NORTHEAST UTILITIES

Docket No. 50-423
B10845

References: (1) B. J. Youngblood to W. G. Counsil, Request for Additional Information for Millstone Nuclear Power Station, Unit No. 3, dated, May 3, 1983.

Millstone Nuclear Power Station, Unit No. 3:
Response to Select Requests for Additional Information

FIGURE 1.2-1
SITE PLAN
MILLSTONE NUCLEAR POWER STATION
UNIT 3
FINAL SAFETY ANALYSIS REPORT

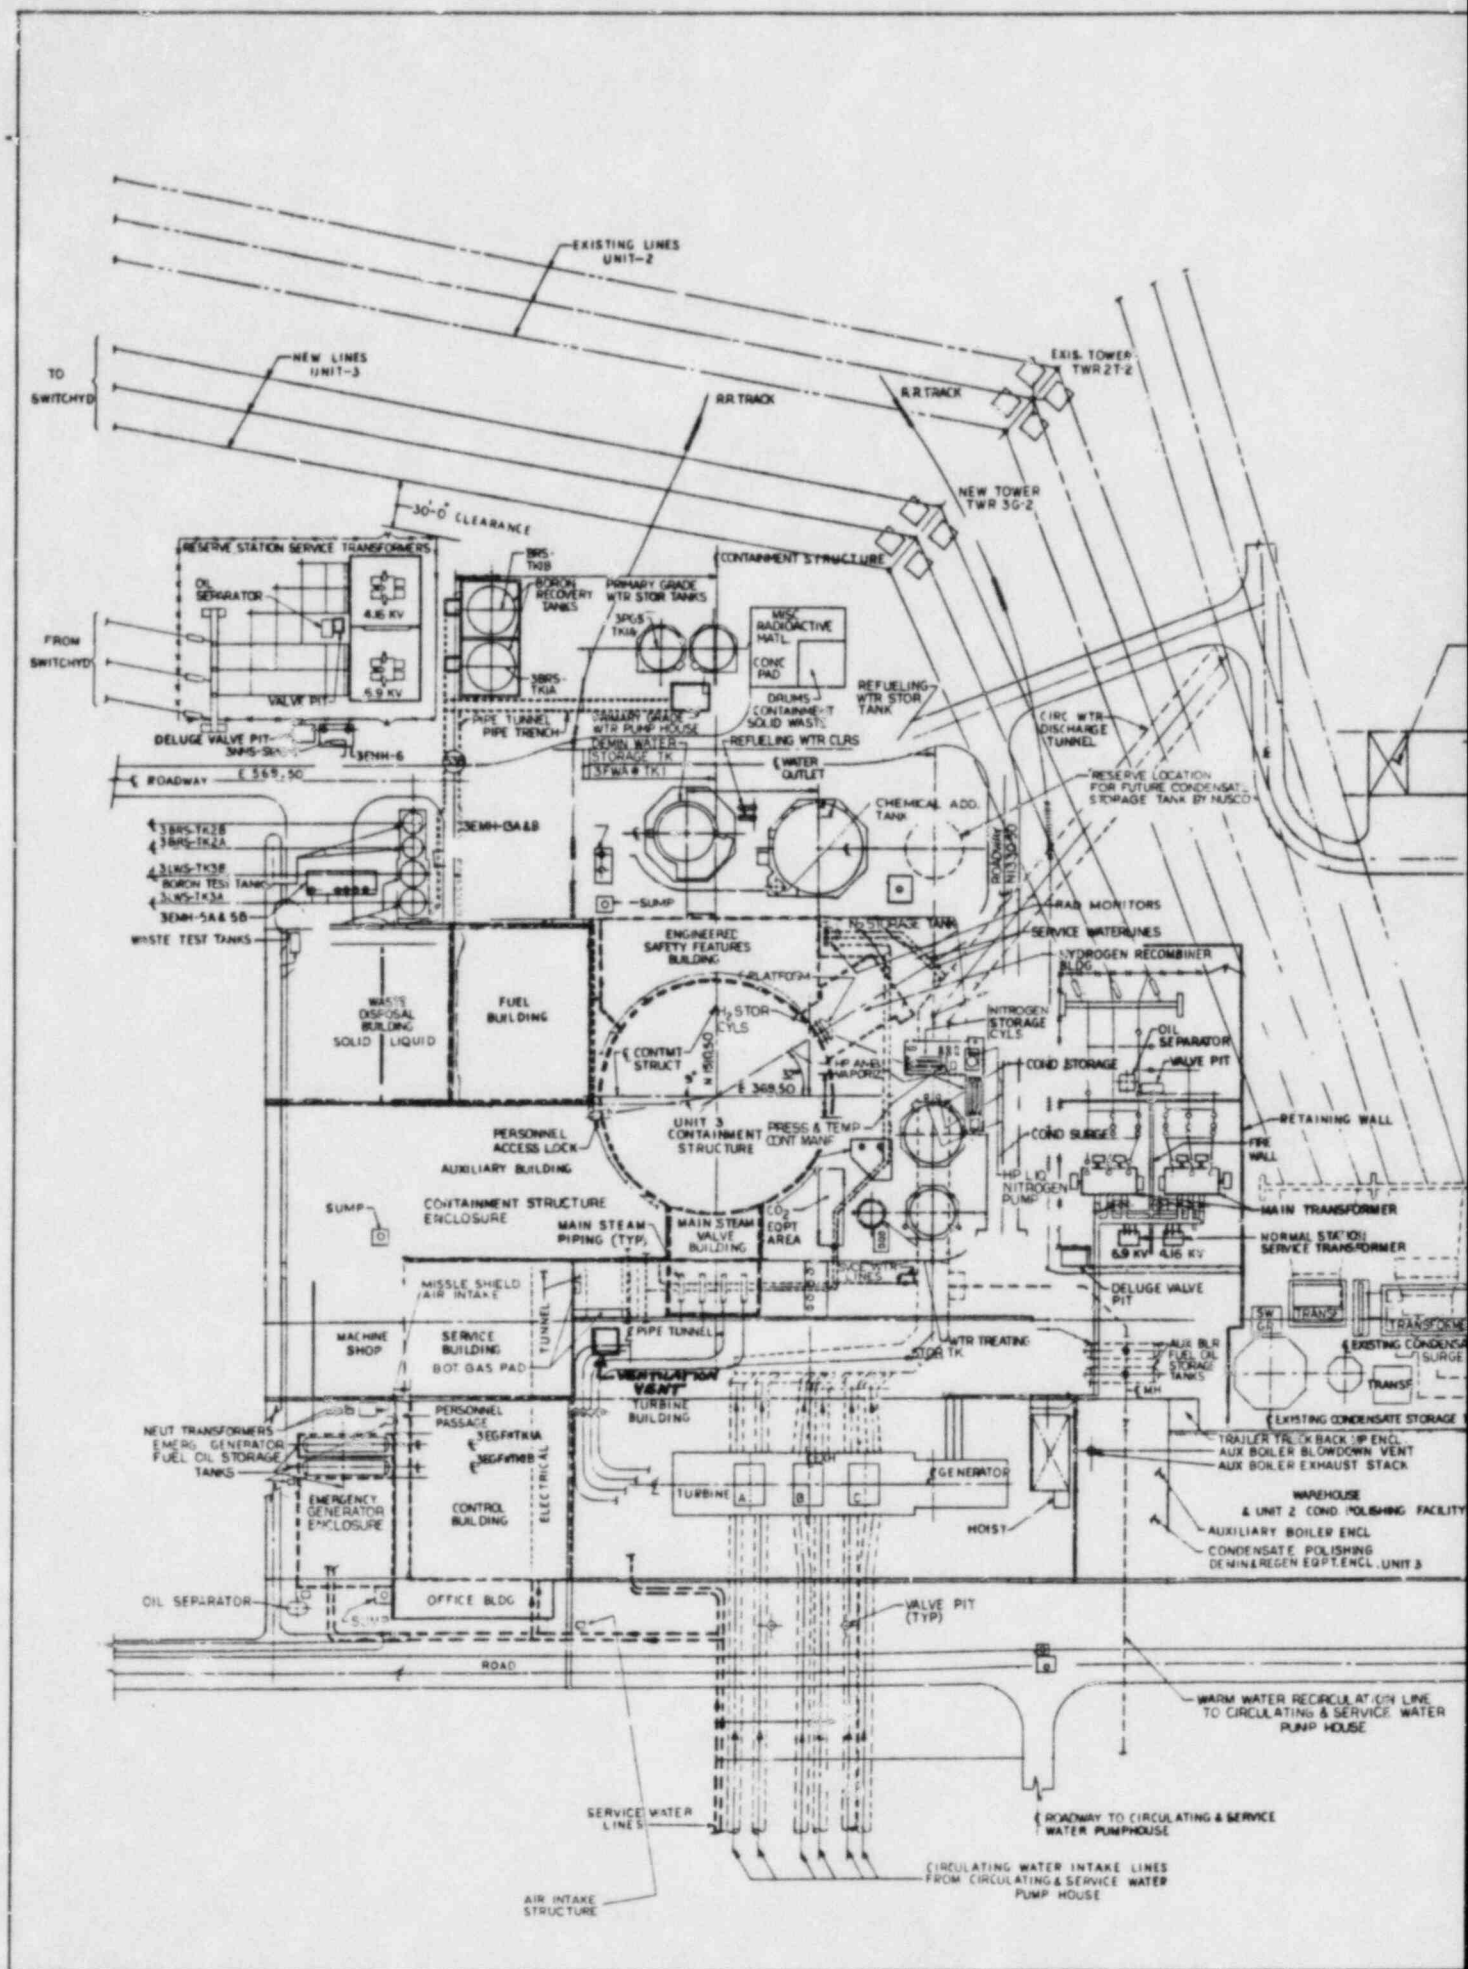
Acceptance Criteria, Requirement II.b, calls for meeting the Positions in Regulatory Guide 1.112. Section 11.3.3 of the FSAR states that the release points are indicated on Figure 1.2-1. Clarify if this should be Figure 1.2-2. Compare Figure 1.2-2 with Figure 2.1-5 of the ER. Provide the information requested in Appendix B to Regulatory Guide 1.112, item 6d, for the height and location relative to adjacent structures. Include the turbine building, warehouse, steam relief vents, and outside tank vents, for example. Provide some detail on how the release lines lead to the stack and the reactor plant vent.

Release points including locations and heights are indicated on revised FSAR Figure 1.2-1 and Figure 1.2-2. Steam vents and turbine building exhausters are shown on revised FSAR Figure 3.8-73. Radioactive tanks are connected to the reactor plant aerated vent system, as indicated in FSAR Section 9.3.3. Air is taken into tanks through the tank vent, and carried out of the tanks by the aerated vent system to the radioactive gaseous waste system (FSAR Section 11.3.3). Ventilation release for the warehouse is discussed in the response to Question 460.15. Information on release lines to the ventilation vent and the Millstone stack is provided in revised FSAR Section 11.3.3.

Release points are identified on Figures 1.2-1 and 1.2-2.

FIGURE 9.3-9 (1 OF 3)
BORON RECOVERY
SYSTEM
MILLSTONE NUCLEAR POWER STATION
UNIT 3
FINAL SAFETY ANALYSIS REPORT

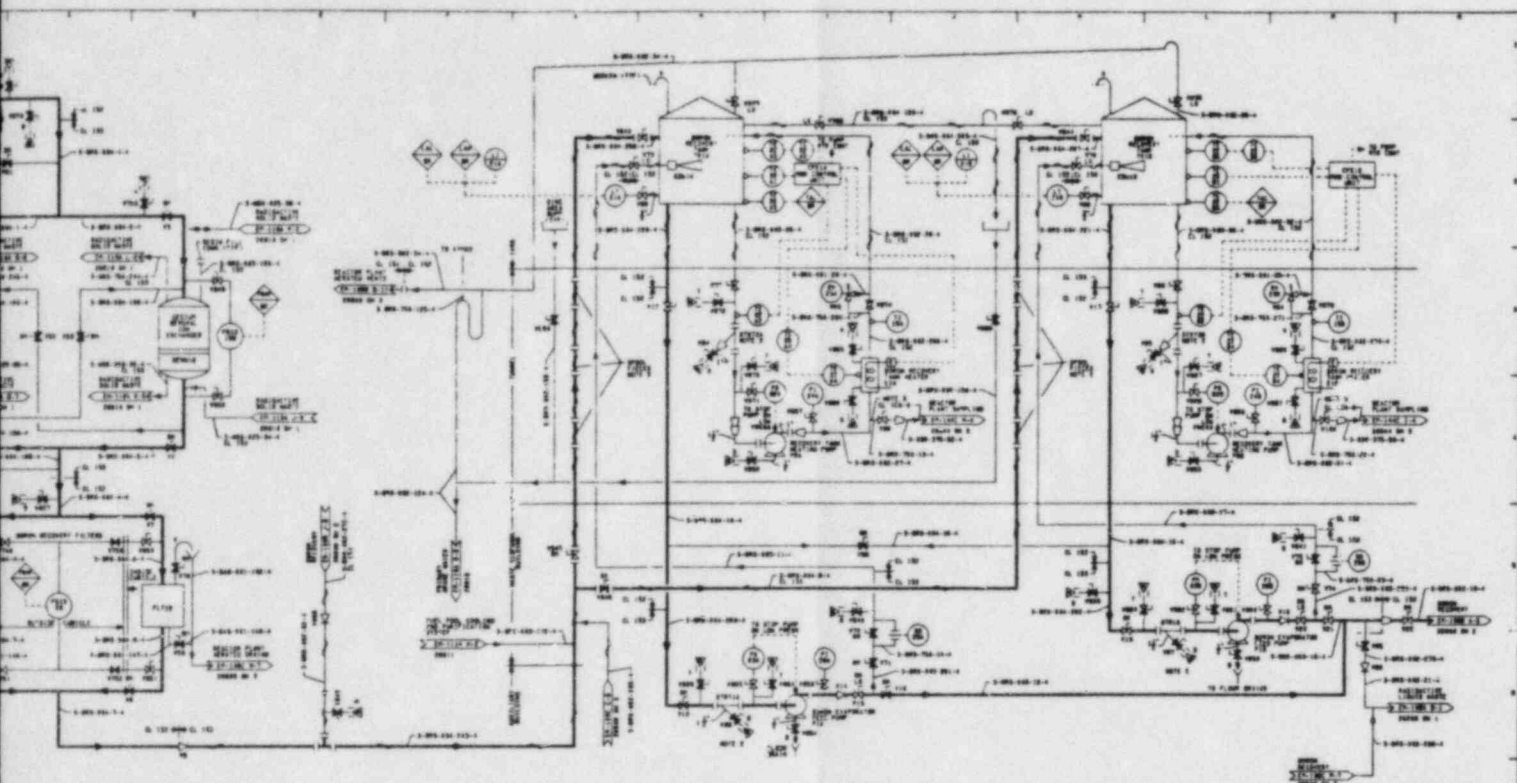
- a. The flow direction of the reactor plant gaseous waste and the condenser air removal lines to the radioactive waste line on Figure 9.3-5 (Sheet 1) at K-9 disagrees with Figure 10.4-2 (Sheet 2) at K-2.
- b. The waste tank inlet and outlet are connected on Figure 9.3-6 (Sheet 1) at K-4 or Figure 11.2-1.
- c. The BRS inlet line EM-109A at E-10 is not shown on Figure 9.3-9 (Sheet 1) at B-2.
- d. Figure 11.5-1 indicates monitor 3HVR-REID. Should this be 3HVR-RE10A and for 10B, as given on Figure 3.8-62 (Sheet 4)?
- e. Figure 9.4-3 (Sheet 2) at I-1 indicates ventilation release to Unit No. 2. How is this line monitored prior to gas release at Unit No. 3?

- c. The connection is located on Figure 9.3-9 (Sheet No. 1) at coordinates A-1. This discrepancy has been resolved in the revised P&IDs (EM-108A, EM-109A).
